11" Pull Out App Option Divider App

STATUS
05
11" Pull Out App Option Divider App
546.31.800

RevNo	Project # or change Request #	Date	Signature	Checked
001	File updated	12.01.2011	NPG	RM

KNIFE TRAY Ap-11" Unit

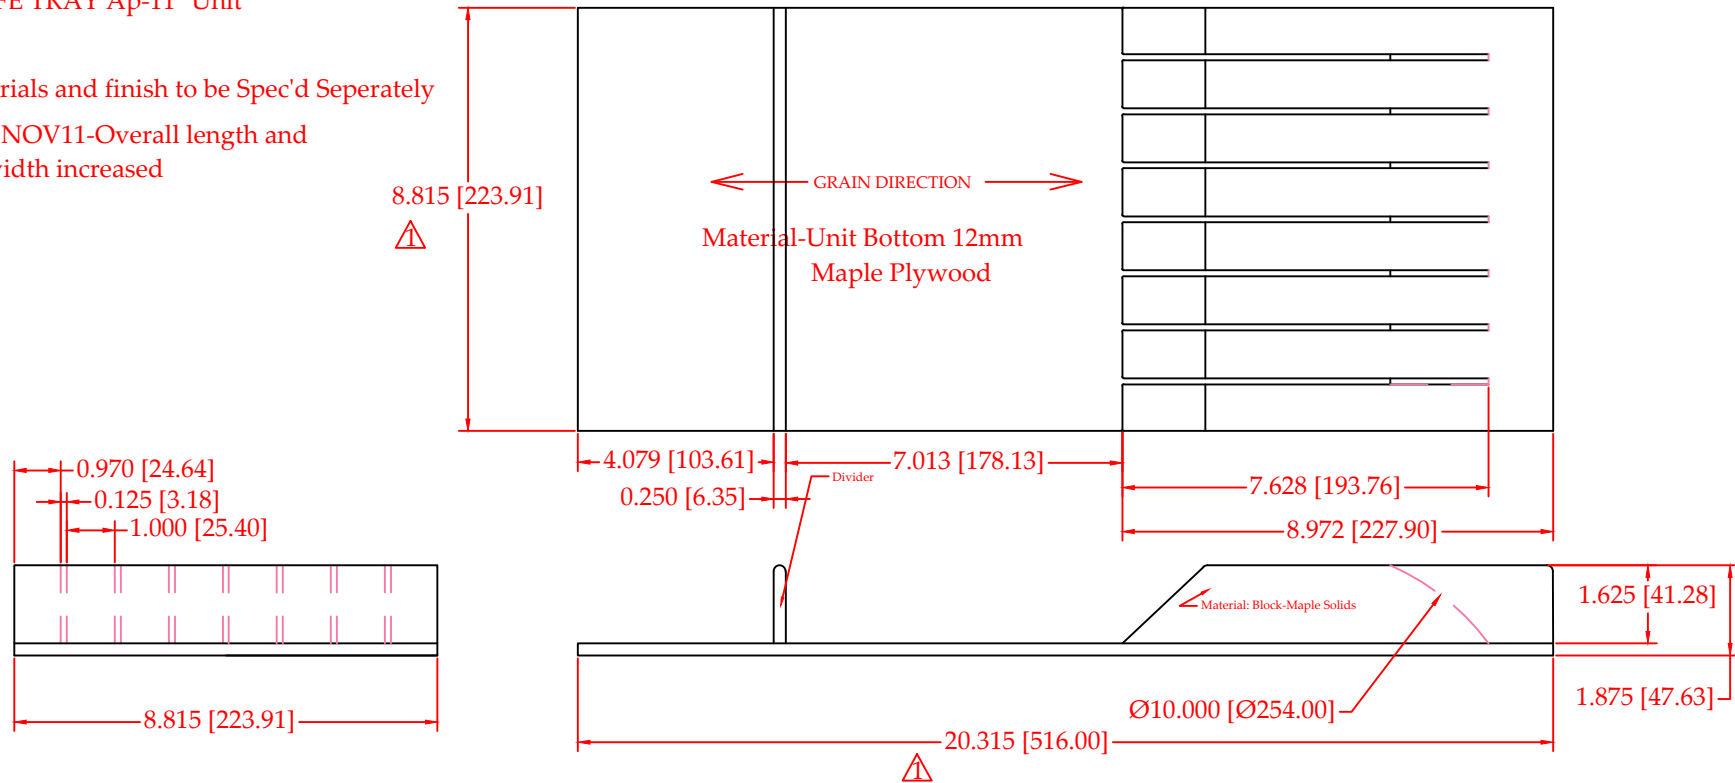
⚠ 11NOV11-Overall length and width increased
